PROJECT TECHNICAL MEMORANDUM

Project : Viadux Phase 2
Our Ref : 28830-PTM1-AGJ-R0
Date : 7 December 2021
Author : Andrew Jameson
To : Deloitte (Planning)

RE: VIADUX PHASE 2, MANCHESTER ES ADDENDUM : NOISE & VIBRATION

Original Scheme – Ground Floor Layout

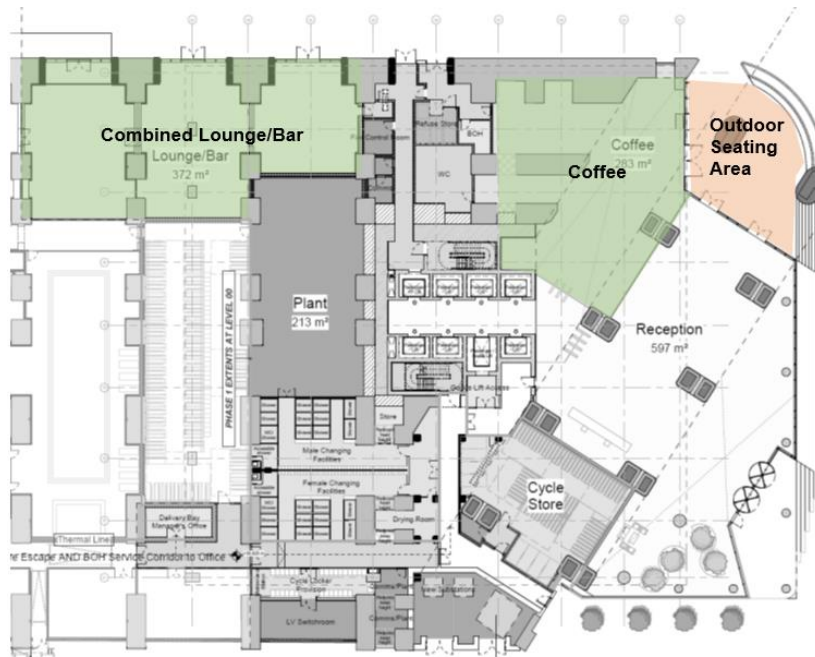
The original scheme included two retail units (1 & 2) at ground floor off Great Bridgewater Street which have now been combined into a single residential lounge/bar unit. Retail unit 3 will now form a larger office reception spaces and coffee shop with an outdoor seating area. See below Figures.
